APPENDIX A
Comment Letters

**Index of Written Comments Received on the DEIS
Blood Brothers - Sheldrake**

**Subject: Referral File No. MMV 06-010 – Sheldrake River Project/Estates Condominium
Zoning Map Amendment; Site Plan Application
Draft Environmental Impact Statement**

Figure 3.5-9: Percent Distribution Site Generated Trips

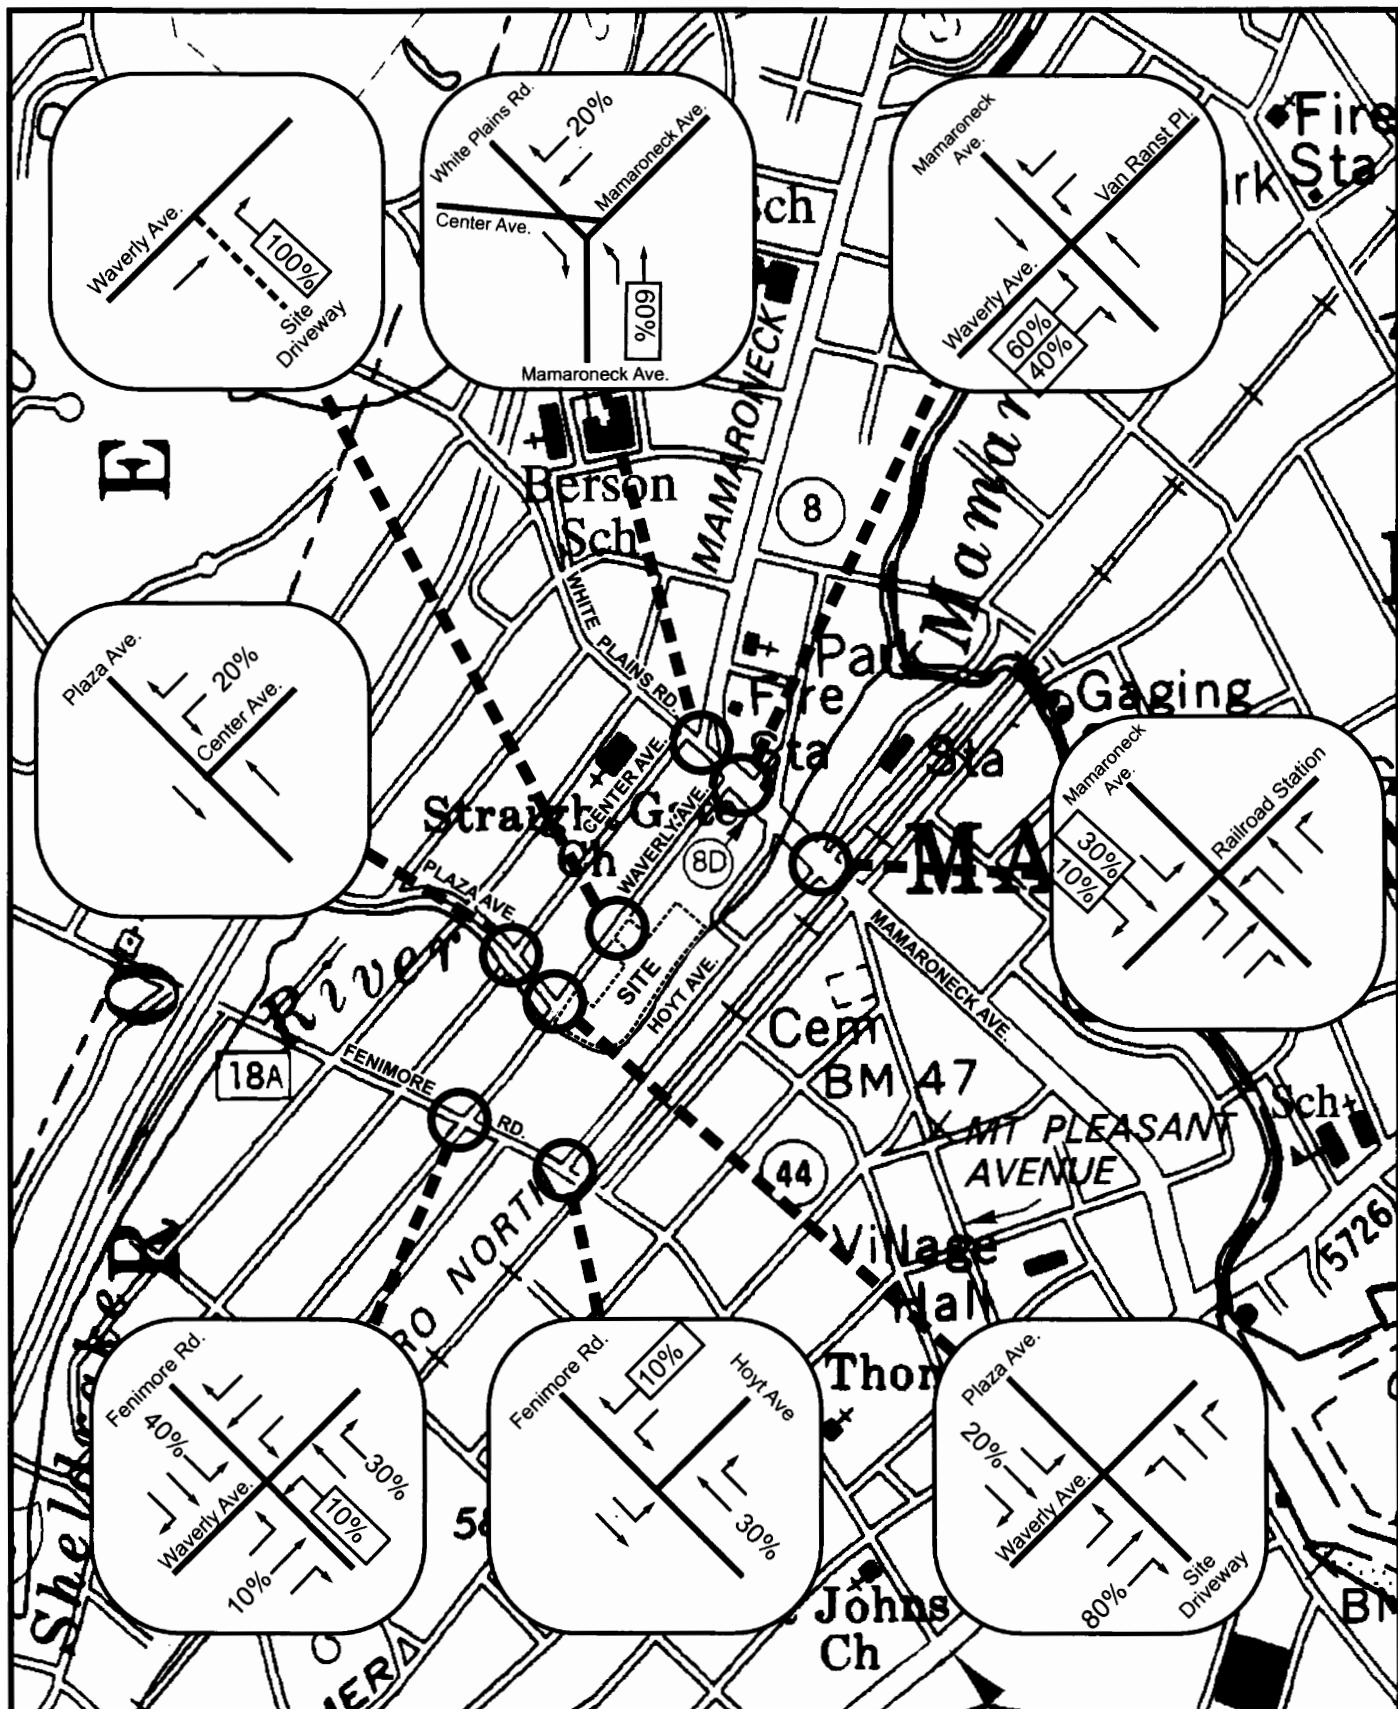
Comment 1 (Memorandum from Georges Jacquemart, BFJ Planning, June 26, 2006): Our comments have been responded to in a satisfactory manner, except that there seems to be a traffic assignment mistake related to the percentage of outbound traffic assigned to Mamaroneck Avenue southbound to Hoyt Avenue... Comparing figures 3.5-9 and 3.5-14 in Appendix E, it appears that not all the traffic in figure 3.5-9 making a right turn at Waverly and Mamaroneck was assigned to Mamaroneck and Hoyt and to Hoyt Avenue.

***Response 1:** A typographical error occurred in that Figure 3.5-9 should have 30% southbound through traffic not 10%. Site generated and Build Condition volumes are correct as are the level of service analysis. Figure 3.5-9 is attached as corrected. The revised Figure 3.5-9 should be used in the FEIS.*

Figure 8-4 : Landscaping Plan

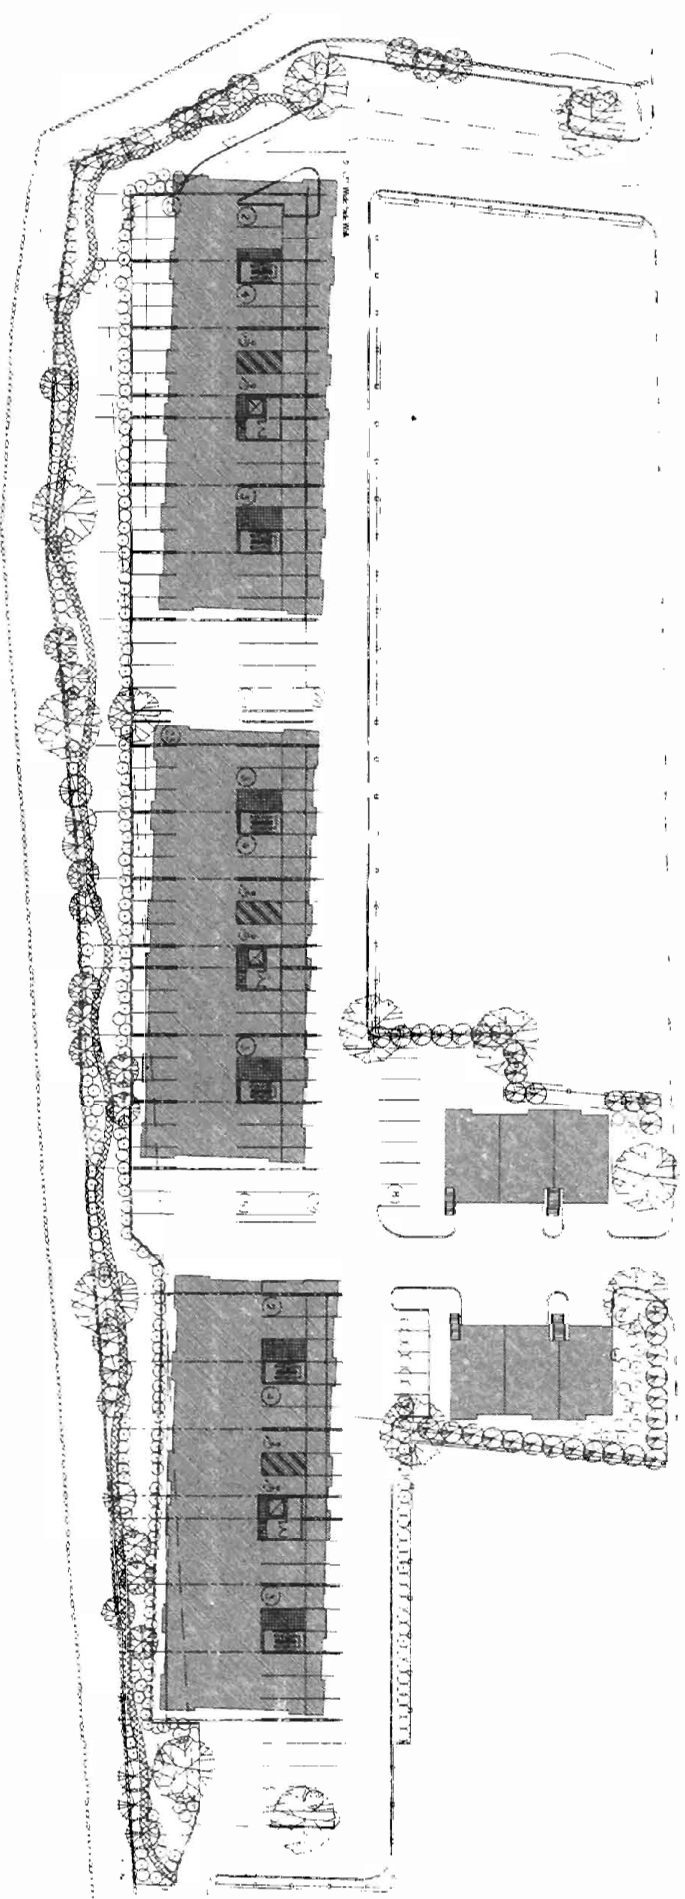
Similarly, the site plan should be required to be revised to provide the proposed walkway along the Sheldrake River, which the draft EIS states could be open to public access. We strongly support this concept as it could serve as an amenity for all area residents. Furthermore, as land uses in the area

Response 5: The July 7, 2006 Landscaping Plan (Figure 8-4) shows the walkway concept extended from the emergency access past the three buildings along the river front. This has been attached in a reduced format for faxing. The entrance maybe modified in final site design as a result of further discussion on the entrance design. See also Response 3. Figure 8-4 should be added to the FEIS.

The Landscaping Plan (Figure 8-4) has been modified to include a sidewalk in the landscaped buffer, adjacent to the Sheldrake River, and is attached. The proposed sidewalk would be approximately 3 feet wide, constructed of stone pavers and designed to meander through the landscaped area. The modified Landscaping Plan will be referenced in the accepted FEIS.
